# Intel<sup>®</sup> Communications Chipset 8900 Series

**Specification Update**

*June 2016*

**Figure 2. 1000BASE-BX/FC-PI Transmitter Electrical Specifications**

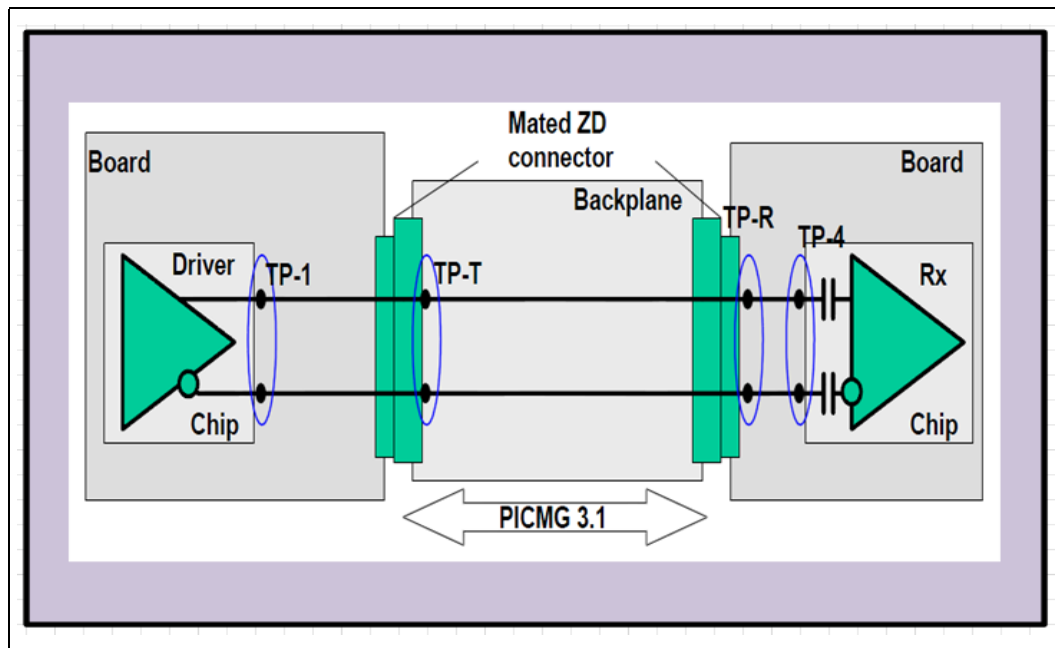
**Implication:** Although this is a specification violation, it does not affect the functional operation of the interface.

**Workaround:** Ensure that the signal routing length from TP-1 to TP-4 is greater than 10". Refer to *Intel® Communications Chipset 8900 Series Platform Design Guide (PDG)* for maximum routing length. (See Figure 2.)
